STILL KRAEGER

110 Winter St
Portland ME 04102

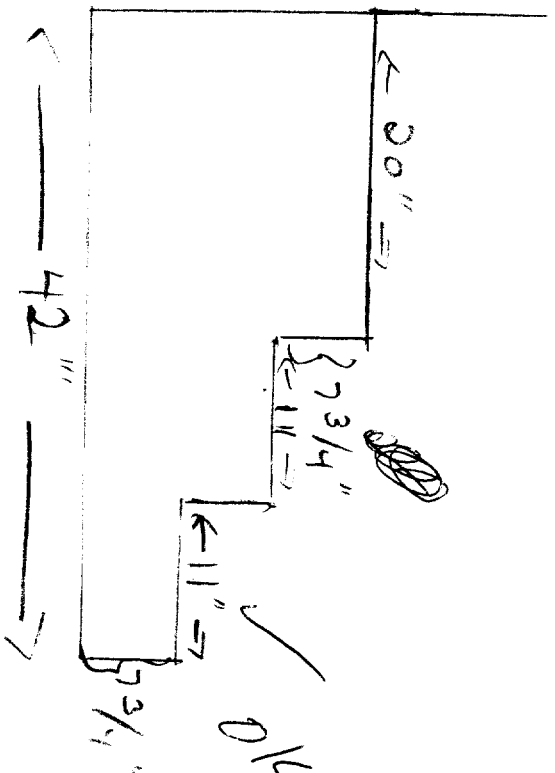
OK - under 3403.4 x
limited zoning -
will be be
in driveway

existing steps are 45" deep

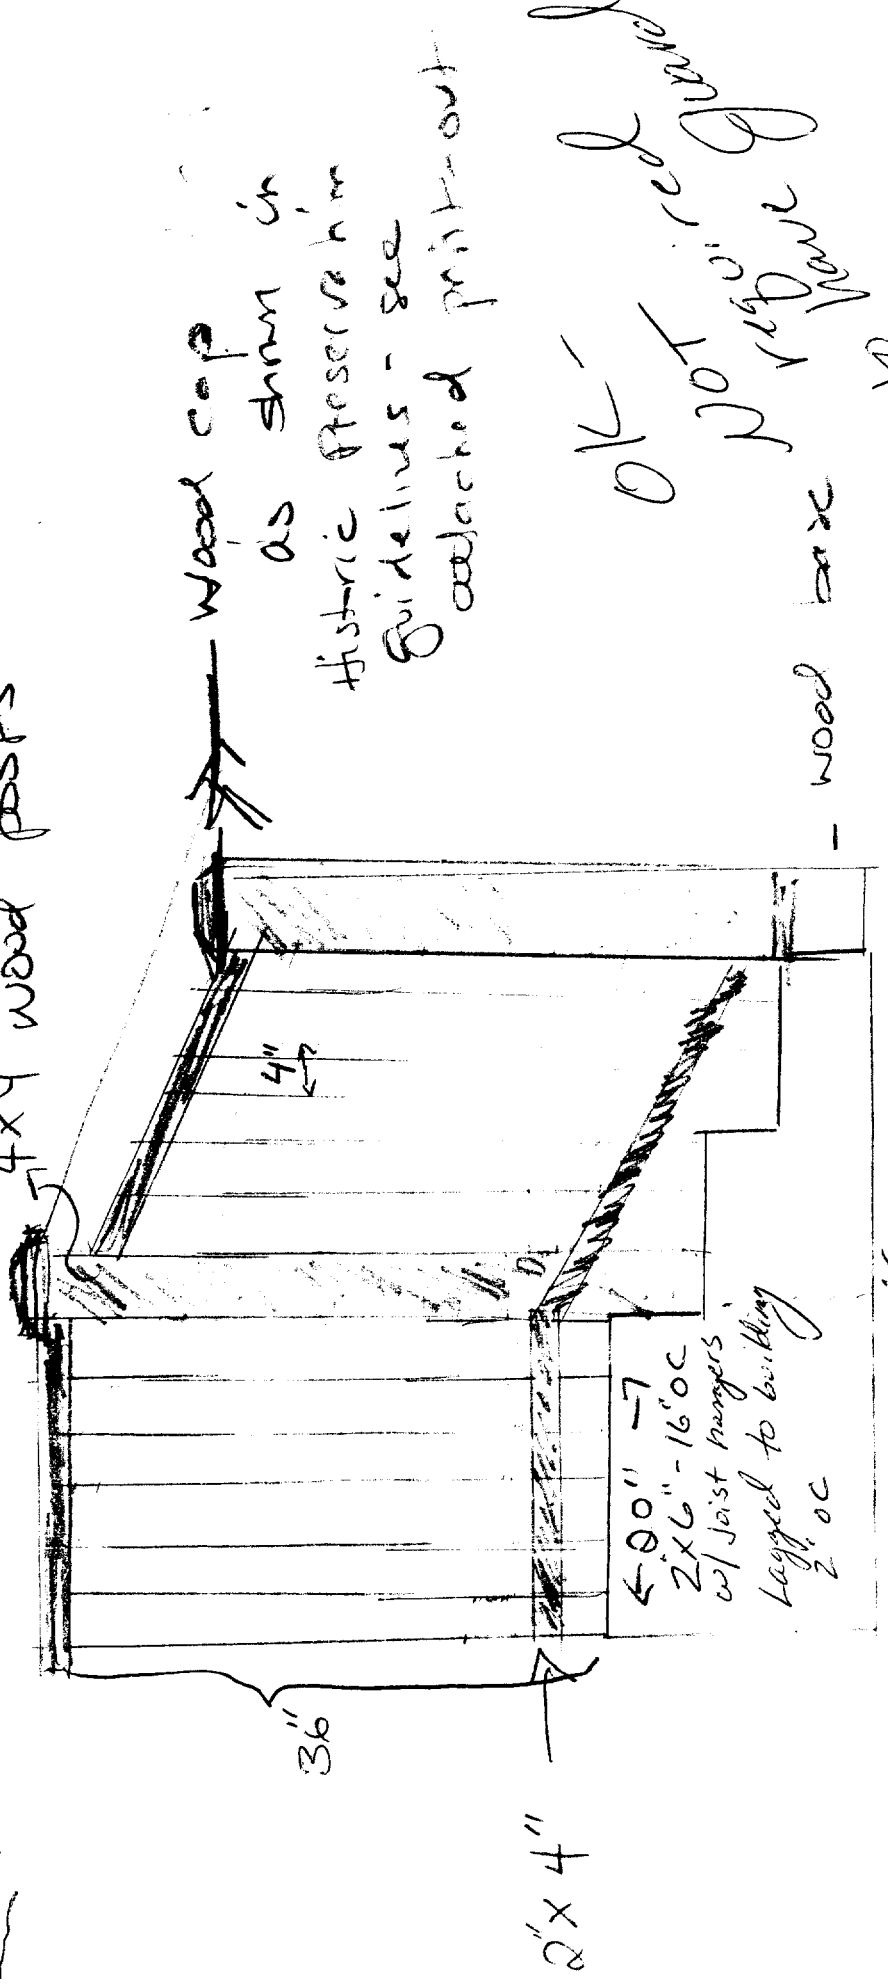
new ones will be 42" -

width of steps will be 78" - existing steps are 72"
new door surround & thin area be

4" face between balusters

4x4 wood posts

Wood cap
as shown in
Historic Preservation
Guidelines - see
attached print-out

OK -
NOT required
Newel post
Newel base

Stair stringer - 22" - 1
will be 2"x12"
